POWER PLANT - NACELLE - POWERPLANT - GEARBOX BREATHER - OUTLET DUCT - SEALING COMPOUND
- REPLACEMENT OF - CATEGORY CODE 5 - MOD.NAC-71-0133

V2500-NAC-71-0133

REPLACEMENT OF SEALANT
Fig.1

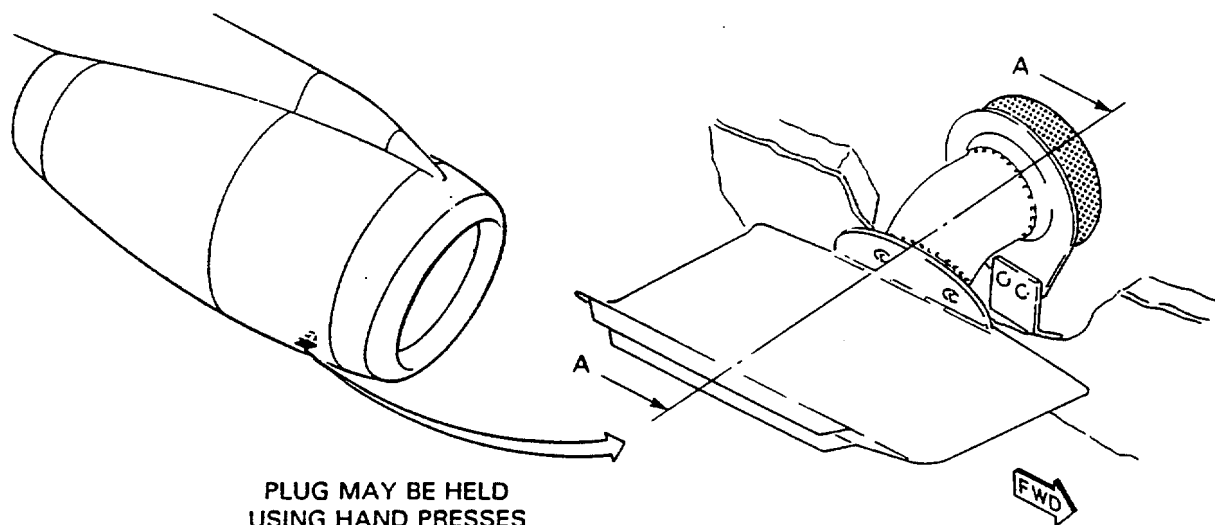
- (1) Open the right hand fan cowl door with instructions in the A320/V2500 Aircraft Maintenance Manual, Task 72-13-00-010-010.
- (2) Find the gearbox breather outlet at the bottom, forward part of the right hand fan cowl door. Refer to figure 1.

- (1) Remove and retain four NAS7203U-3 bolts, four AN960-C101 washers and four H01-3 nuts to release the gearbox vent. Retain the gearbox vent also. Refer to figure 1.
- (2) Remove the HL11VF-6-4 Hi-lok bolt and HL97V-6 Hi-lok collar from the outlet duct. Discard the Hi-lok collar.
- (3) Drill out two CR3523-5-2 rivets to release the outlet duct. Remove the outlet duct.

(4) Clean the mating faces of the outlet duct with trichloroethylene solvent and leave to dry. Apply a liberal coat of PR1422B2 sealant to the mating faces.

(5) Rivet the outlet duct back in position with two CR3523-5-2 rivets.

(6) Install the HL11VF-6-4 Hi-lok bolt and safety with an AN960-C10L washer and H01-3 nut. Torque nut to 40 lbf in. (4.52NM).

(7) Install the gearbox vent back in position with four NAS7203U-3 bolts, four AN960-C10L washers and four H01-3 nuts. Torque nuts to 40 lbf in (4.52 Nm).

LEAK TEST
Fig.2

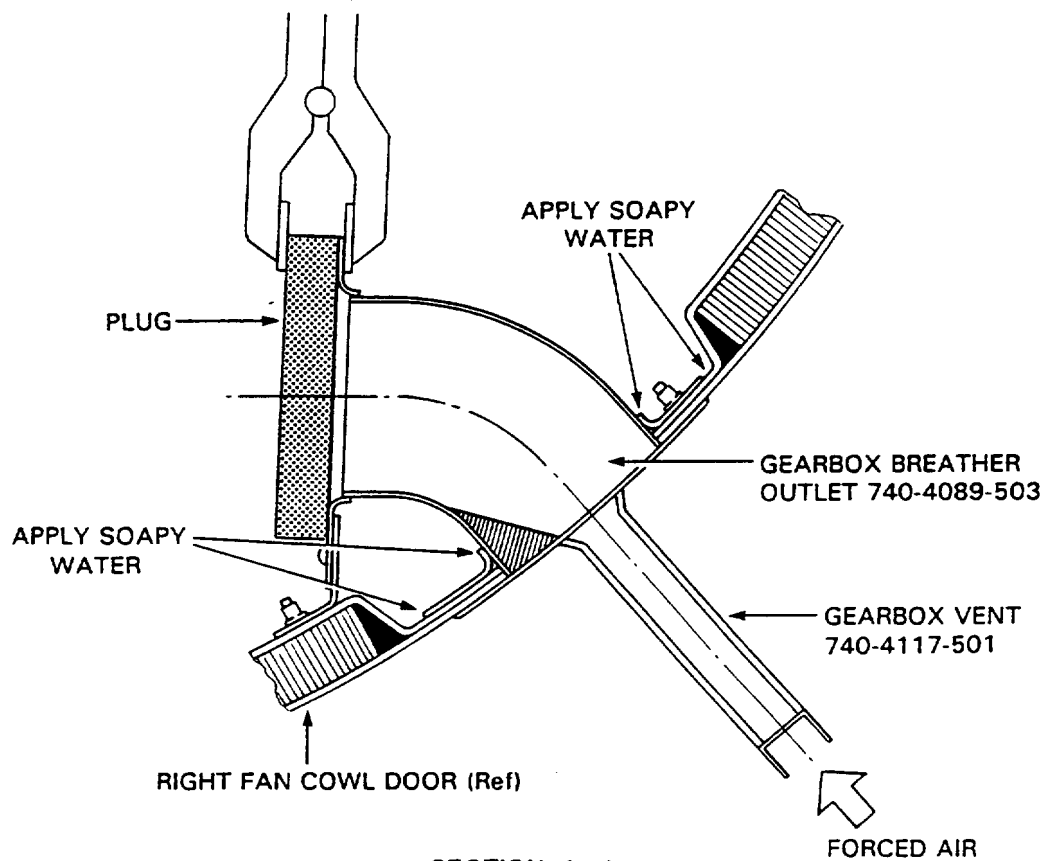
- (1) Do a pressure test of the gearbox breather outlet duct as follows (Refer to Figure 2):
 - (a) Make a plug equal to the diameter of the outlet duct from 0.25 in.(6mm) thick (approximate) silicone rubber sheet.

- (b) Put the plug on the end of the gearbox breather outlet duct (GBOD) as shown. Use hand presses as necessary to provide an effective seal.
 - (c) Put soapy water around the sealed edge of the GBOD as shown.
 - (d) Blow forced air through the gearbox vent and examine for leaks around the sealed edge of the GBOD.
 - (e) If air leaks are found, remove the GBOD and apply sealant again with instructions in step 2.B.
- (2) Close the right fan cowl door with instructions in the A320/V2500 Aircraft Maintenance Manual, Task 71-13-00-410-010.

PLUG MAY BE HELD
USING HAND PRESSES
